BOARD OF COUNTY COMMISSIONERS
ORANGE COUNTY, FLORIDA

ADDENDUM NO. 1, IFB Y14-1006-J2

INSTALLATION, MAINTENANCE AND MONITORING FOR LANDFILL GAS
COLLECTION FOR ORANGE COUNTY LANDFILL CELL 9 & 10

6 LEACHATE RECIRCULATION DISTRIBUTION TRENCH DETAIL

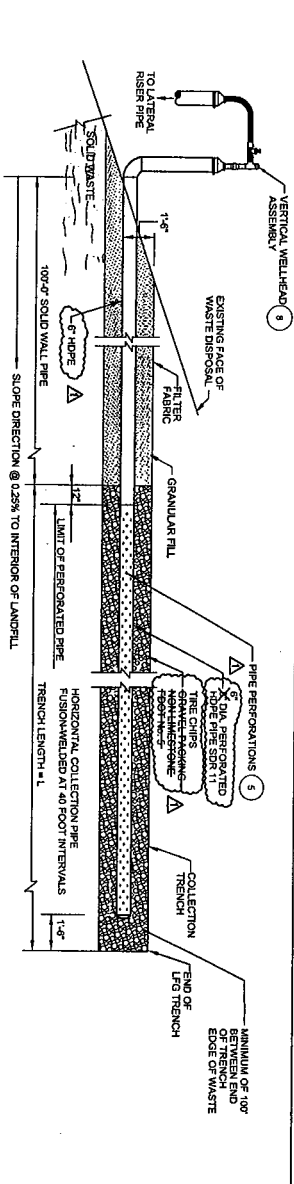
5. Please clarify what type of gravel FDOT #4, FDOT #5 or tire chips for the horizontal landfill gas wells and the leachate recirculation trenches?

Response: Details 1 and 6 on Sheets 17 and 18 are correct. On Detail 7 the note "Gravel packing –non limestone FDOT No. 5" shall be deleted and replaced with "Tire Chips"

7 HORIZONTAL LANDFILL GAS COLLECTOR DETAIL

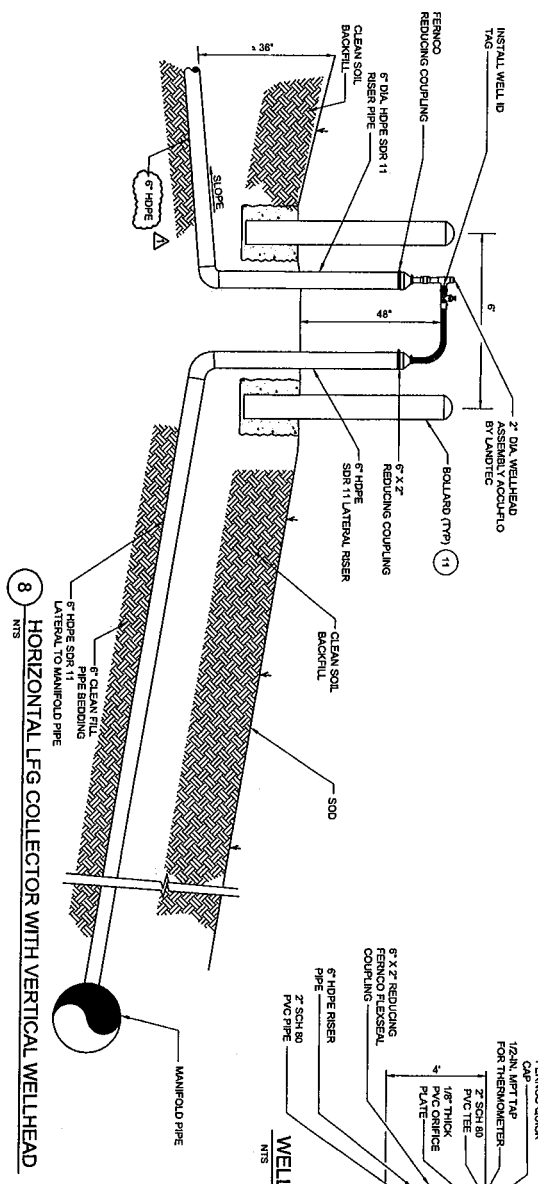
12. On the horizontal collectors the bid form item 6 say 6" HDPE pipe and Detail 7 on sheet 18 of 19 say 8" HDPE?

16. On the horizontal gas collector detail on sheet 18 it show 100 feet of solid pipe per collector. Which line item should this footage be included?

Response: The perforated pipes for the horizontal collectors are 6-inch diameter. Detail 7 has been revised. Please see revised Sheet 18 of 19 attached.

Response: It is included in 6-inch Perforated HDPE Pipe (Horizontal LFG Collector)
